RE: Data Response, Set 1A  
Vernon Power Project (06-AFC-4)

**DATA RESPONSE, SET 1A**

# VERNON POWER PLANT (06-AFC-4) DATA RESPONSES, SET 1

Fogging Frequency Curve for  
City of Vernon

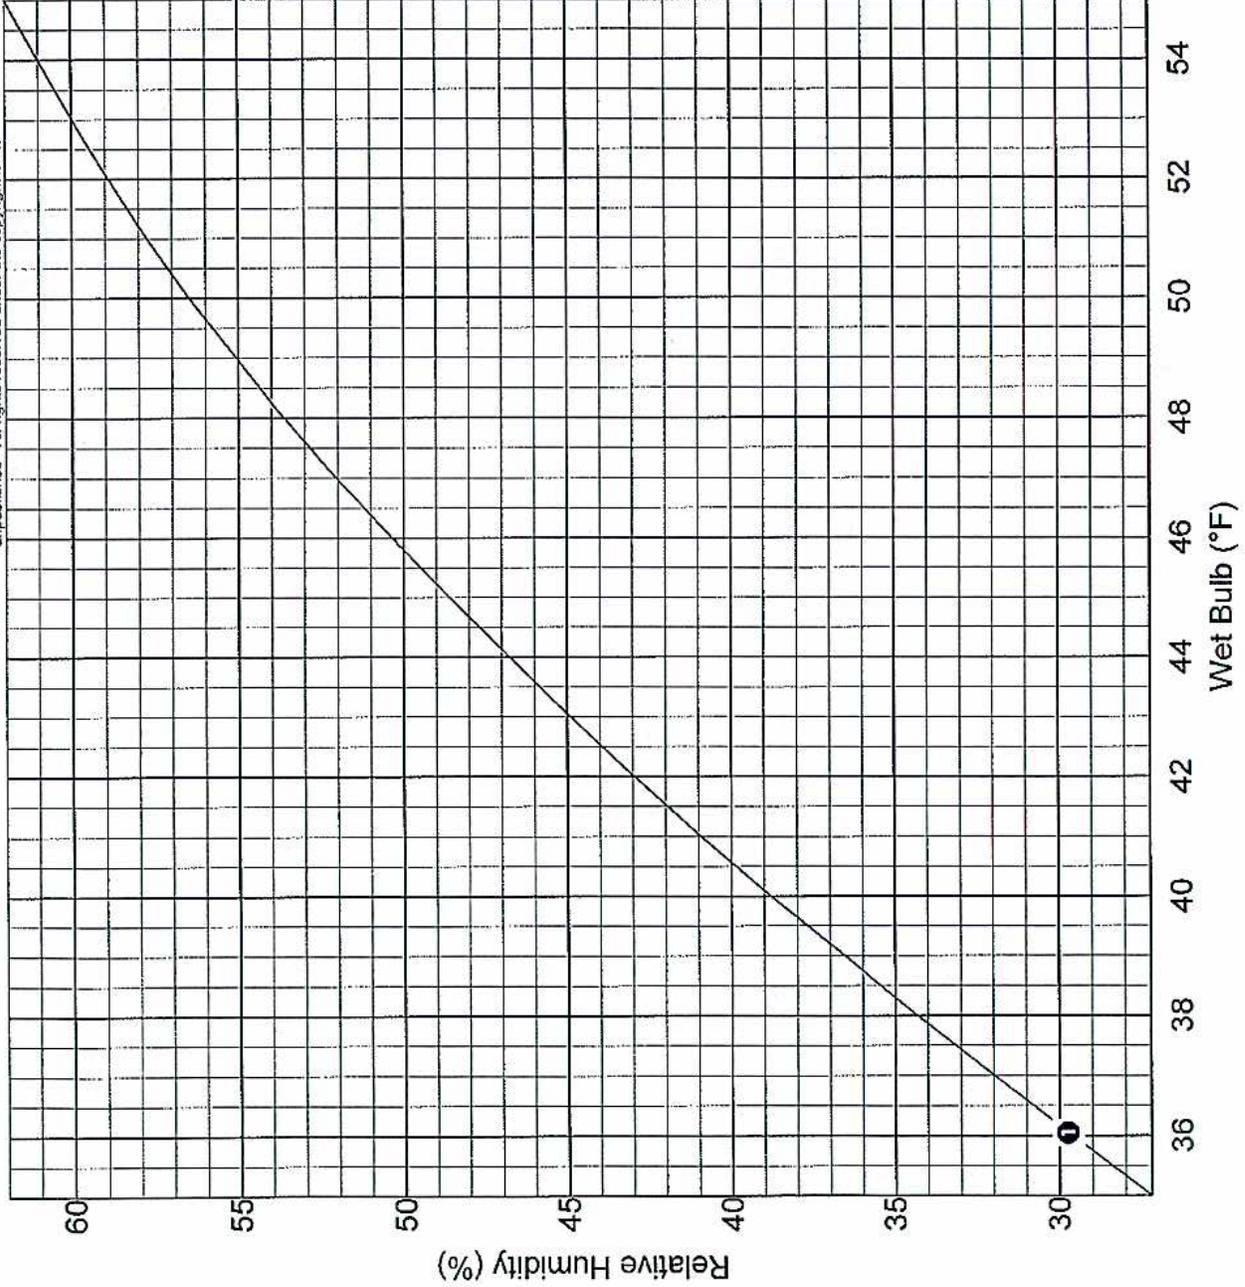
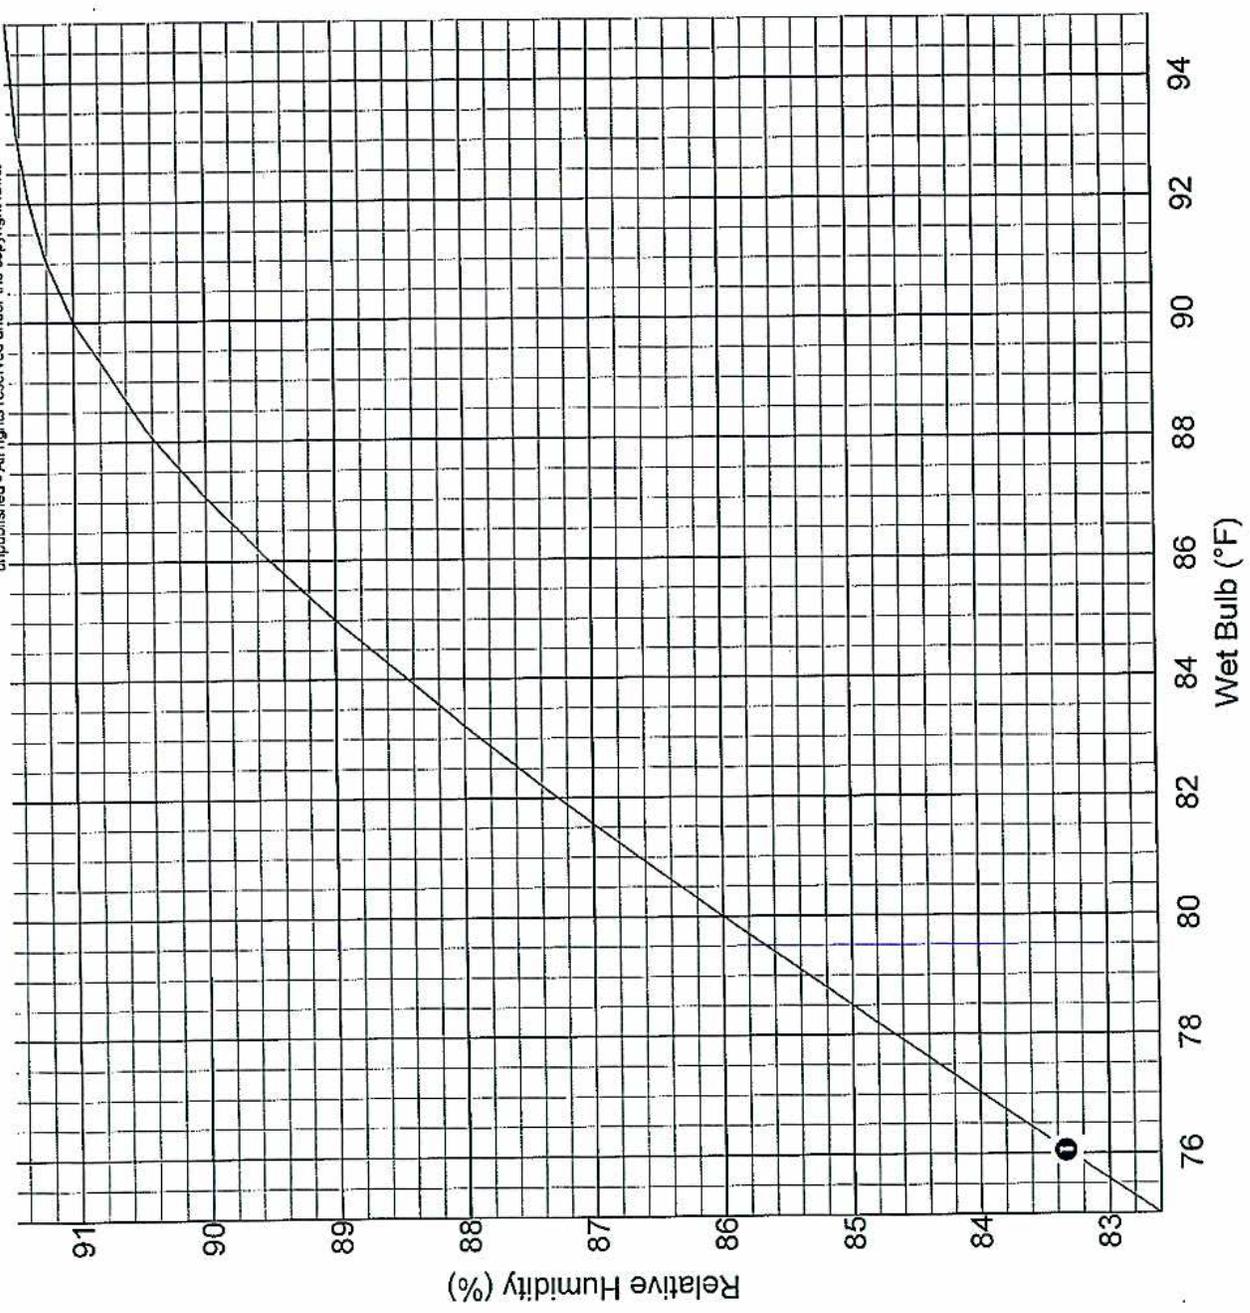
16. Please provide a fogging frequency curve from the cooling tower vendor, if available.

**Response:** A fogging frequency curve is provided as Attachment AQ-16.

**FIGURE S&W30-1**  
**CONCEPTUAL CONSTRUCTION**  
**DRAINAGE PLAN**  
 VERNON POWER PLANT  
**CH2MHILL**

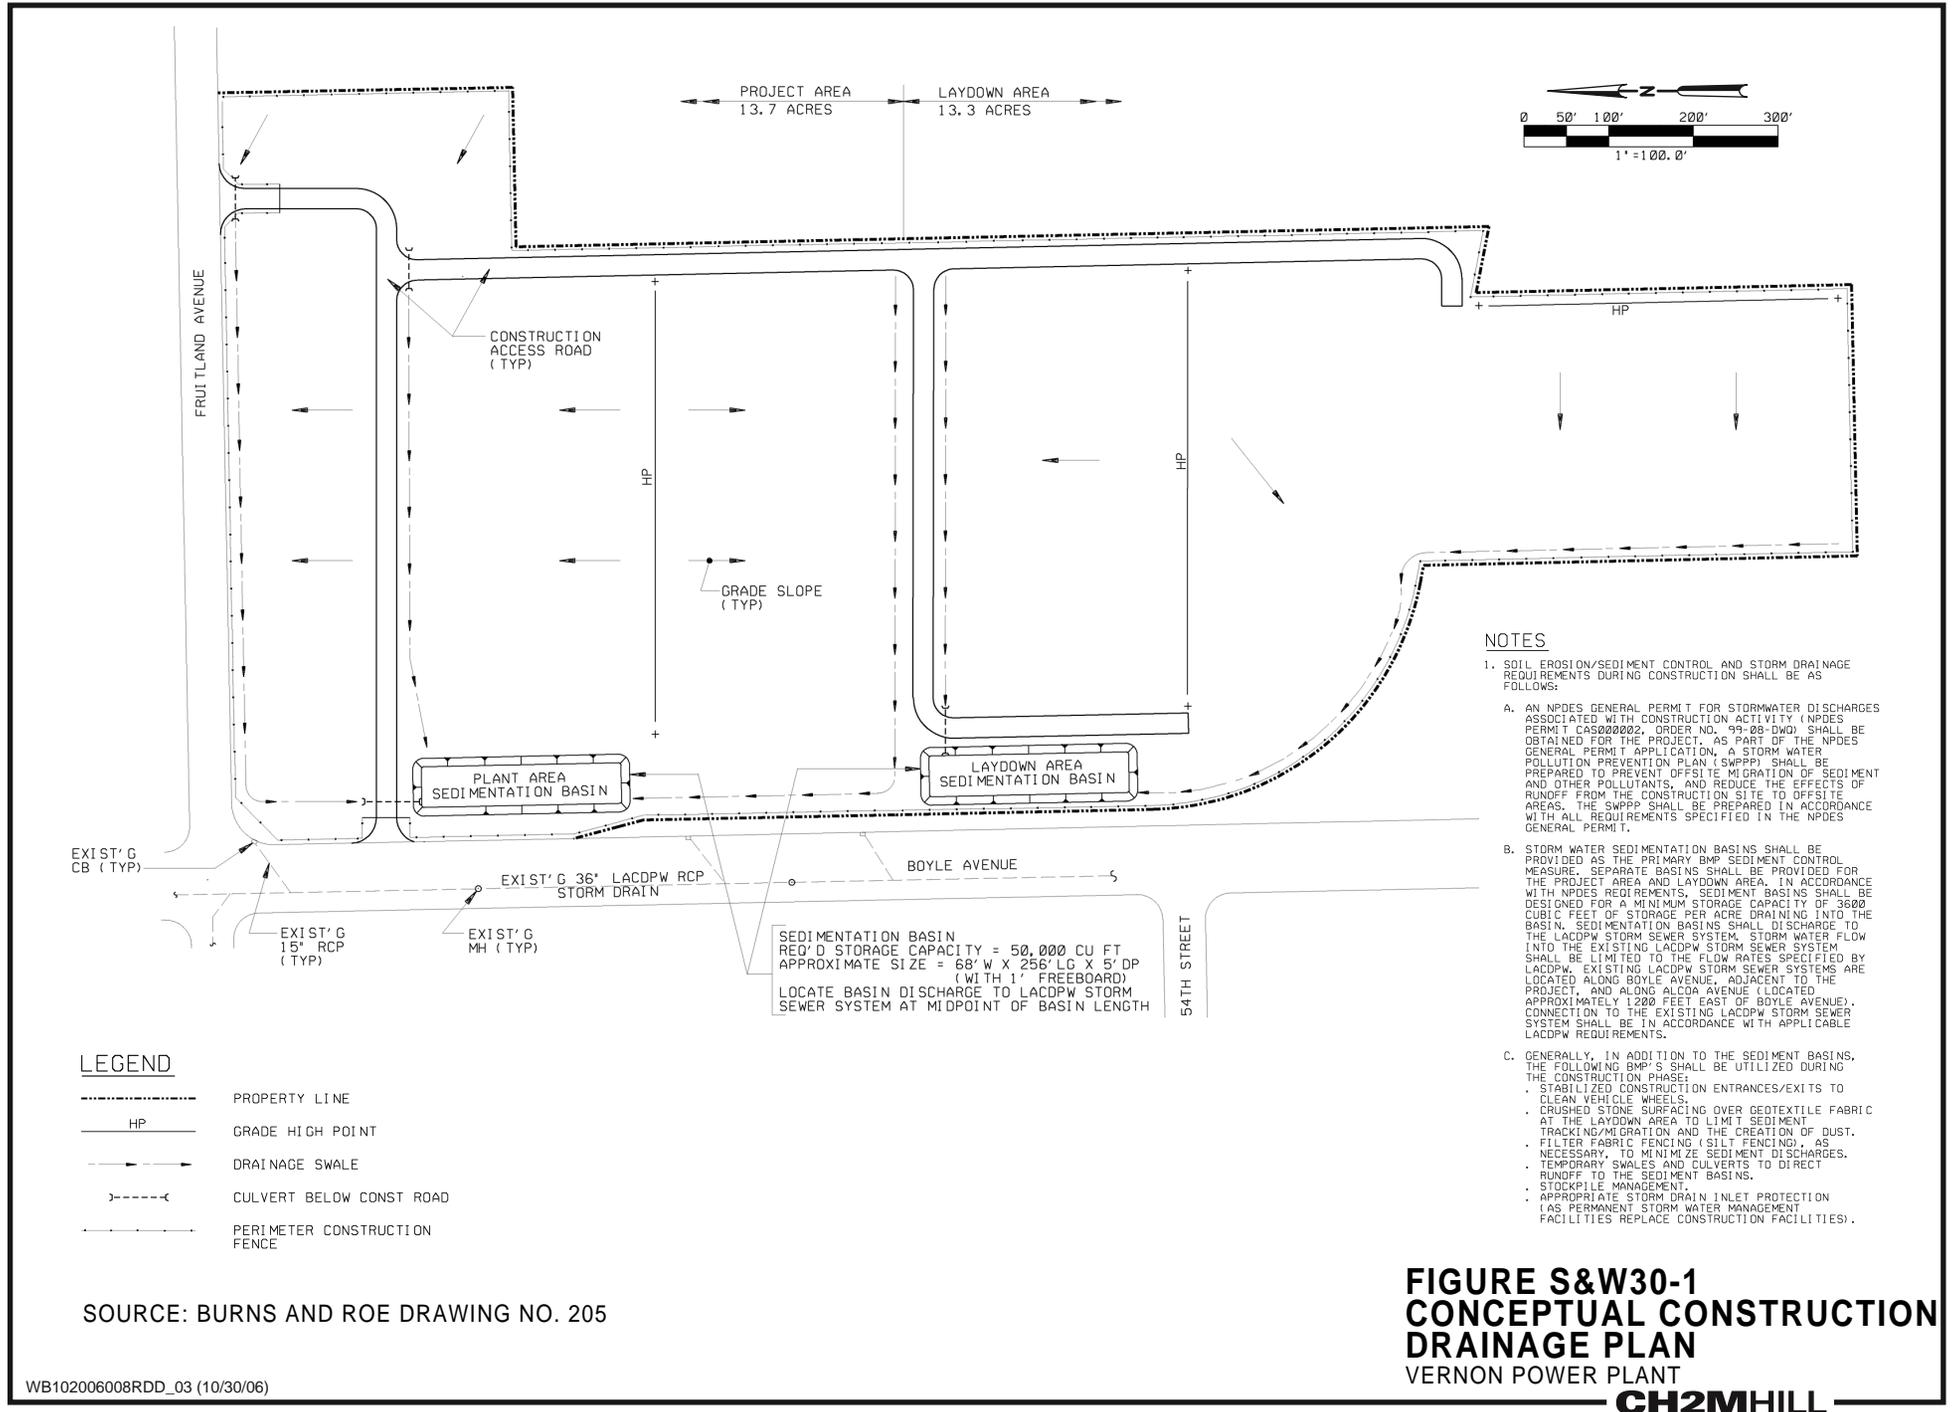
30. Figure 1-4 in the Construction DESC/SWPPP provides a Conceptual Drainage Plan applicable to operations rather than construction. Please provide a Conceptual Drainage Plan applicable to construction, encompassing the combined total 27-acre generation and laydown/parking sites. The Conceptual Drainage Plan should indicate temporary drainage

**Response:** A conceptual Drainage Plan during construction is provided as Figure S&W30-1.
